# Memorandum

To	Piper Peterson – EPA	Page	1
CC	Roy Kuroiwa, Stacy Heilgeist, Kym Anderson – Port of Seattle; Mary Mitchener – City of Seattle; Ben Starr - Integral		
Subject	Terminal-117 – Upland and Sediment NTCRA, Additional Bank Removal at South Park Marina		
From	Winston Chen, Anne Fitzpatrick – AECOM		
Date	March 6, 2014

On behalf of the Port of Seattle, additional sediment removal is being proposed in the South Park Marina bank area (see Figure 1) associated with the Marina Removal Area in the project construction plans. We are requesting EPA’s review and approval of this additional work.

Figure 1 – Additional Marina Removal Area

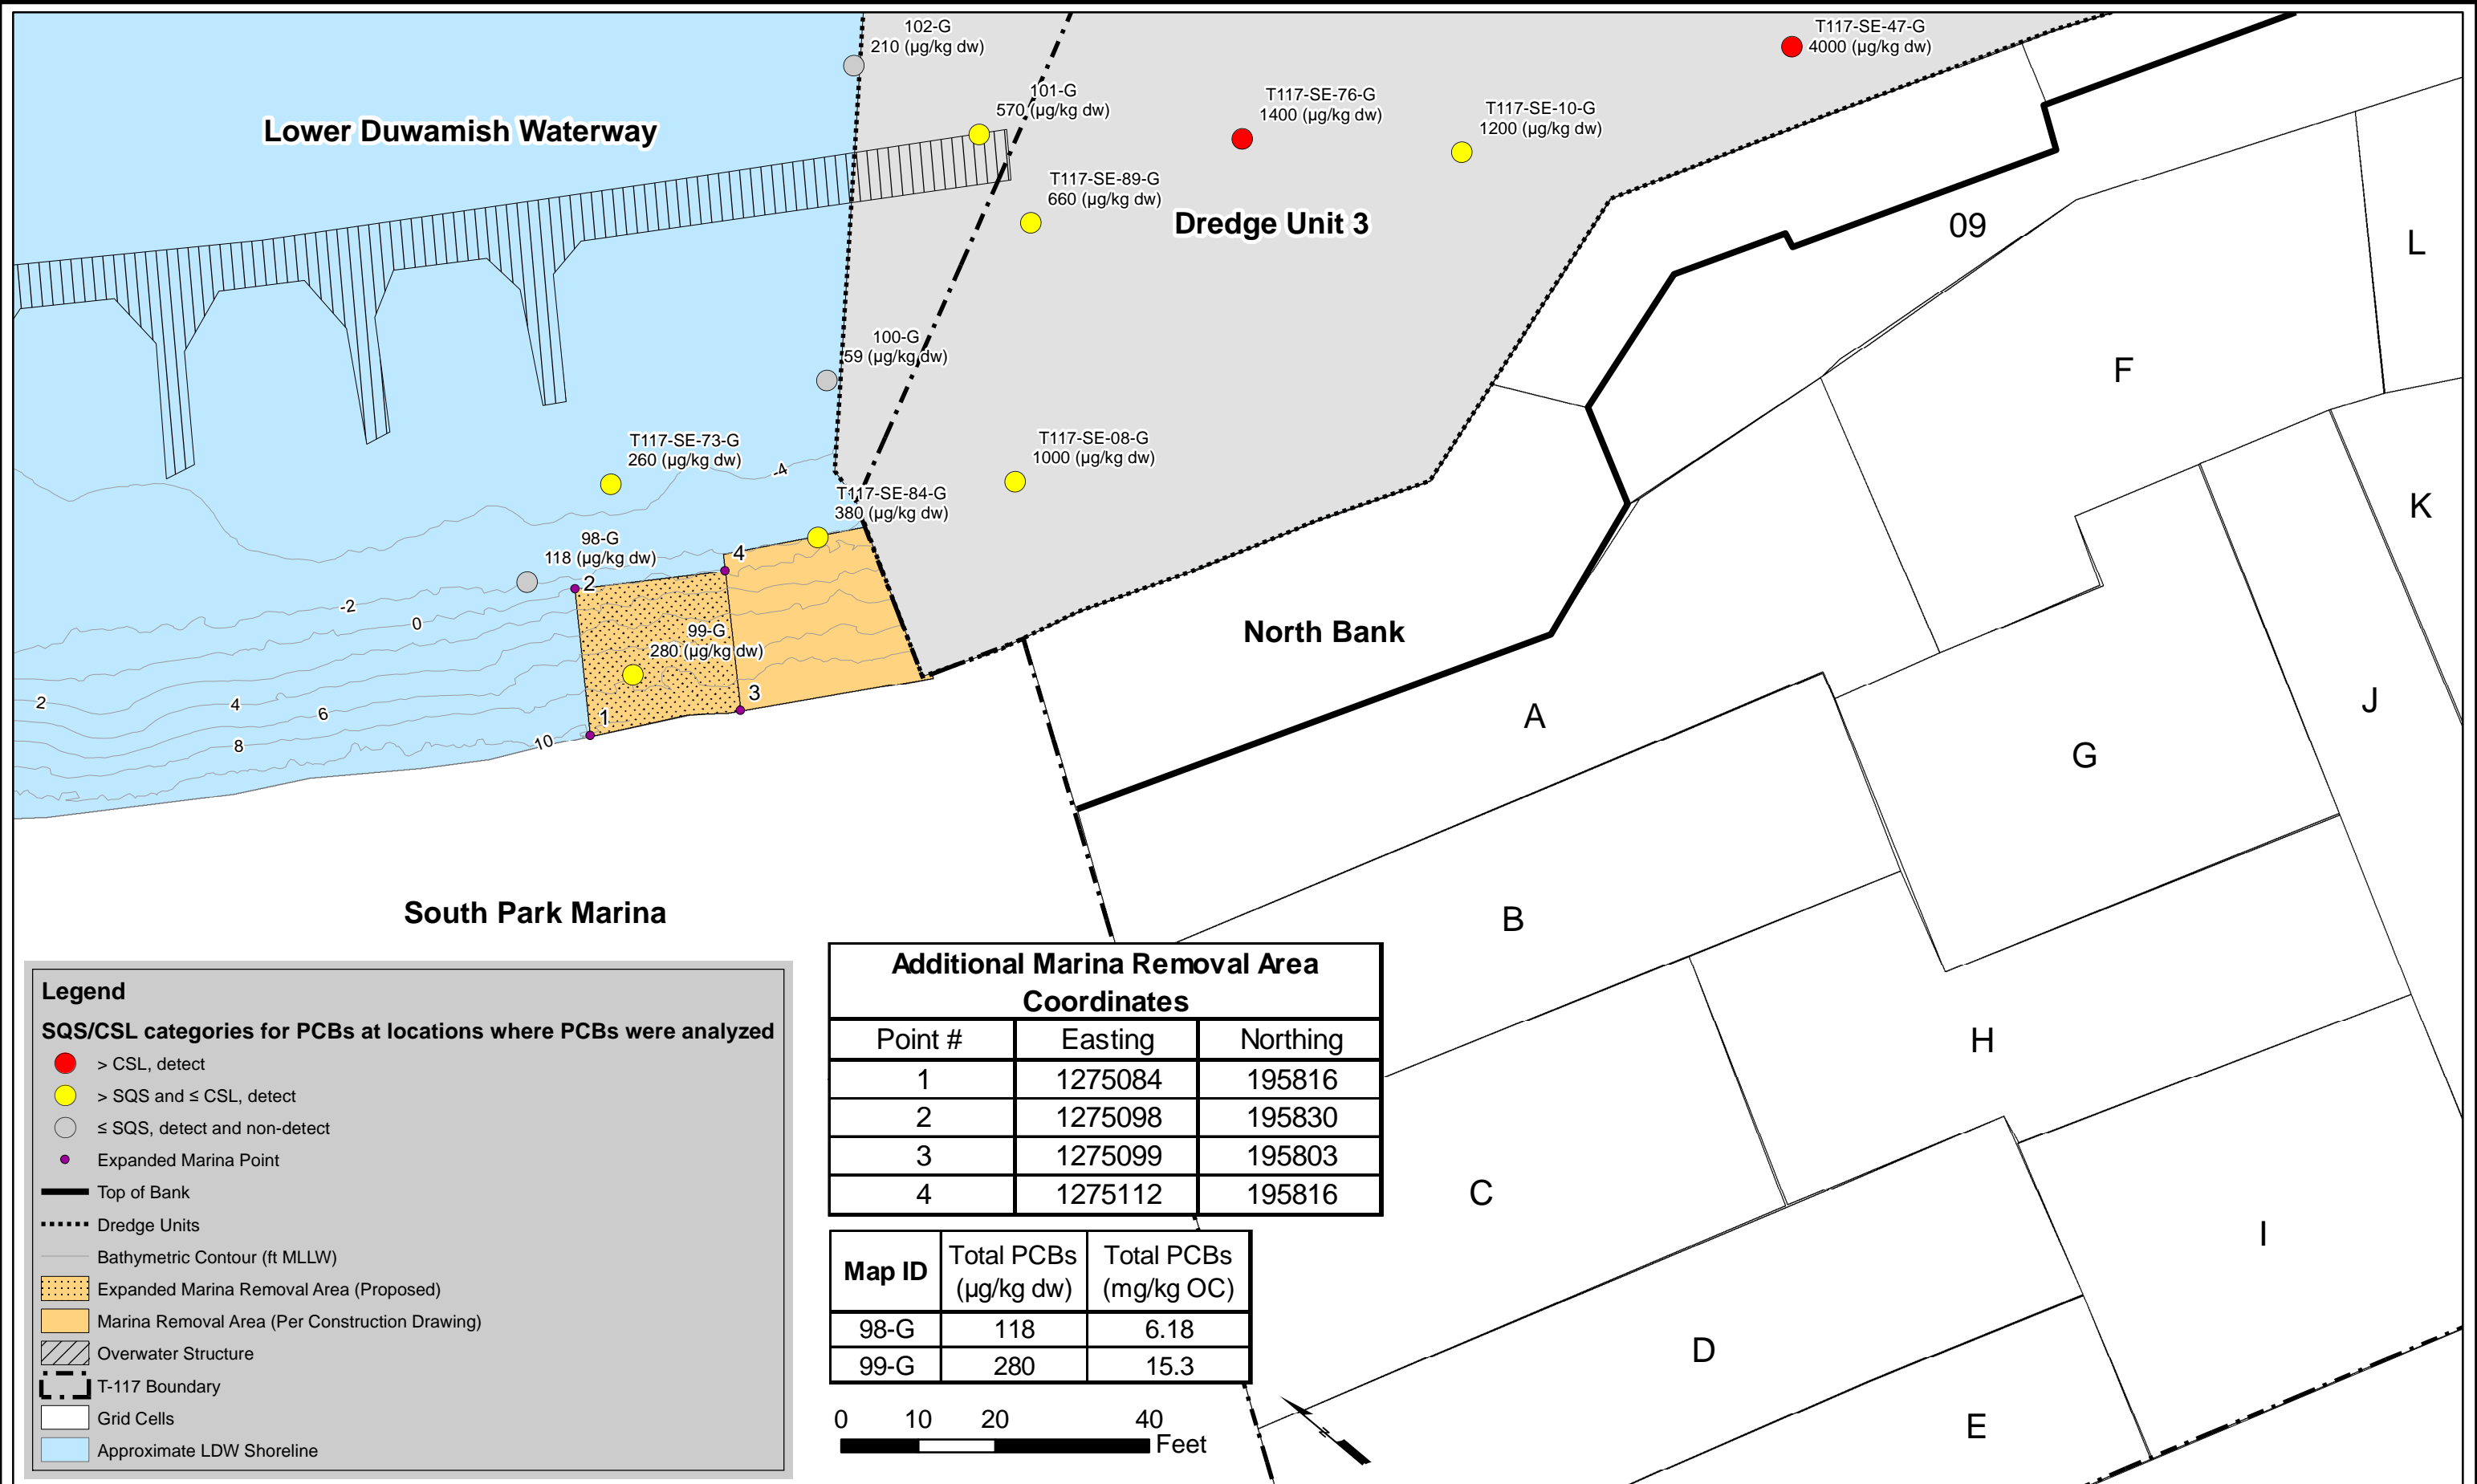
**Additional Removal and Backfilling.** The Port intends to perform additional removal to include station 99-G, by extending the original area to half of the distance between 98-G and 99-G (about 20 ft from the former boundary). The proposed additional SPM removal area is indicated on the attached site map (Figure 1).

This work will be performed at low tide while the area is not inundated by water. Coordinates of four corners of the additional removal area are provided in the attached site map (Figure 1). The contractor will stake out the corners prior to the removal work. The Port will observe the removal activities to ensure the removal is completed as specified. In accordance with the project plans and specifications, no confirmation samples will be collected after this additional removal is completed. The sediment removed from the area will be collected and analyzed for off-site disposal by the Port. One soil sample will be analyzed based on the same analytes as listed in the approved waste profile (i.e., Subtitle D) previously developed for the sediment removed from the Marina Removal Area. After the completion of the removal, the area will be overlaid with riprap protection with the materials specified in Specifications Section 02300, 2.03.

Additional Marina Removal Area Coordinates		
Point #	Easting	Northing
1	1275084	195816
2	1275098	195830
3	1275099	195803
4	1275112	195816
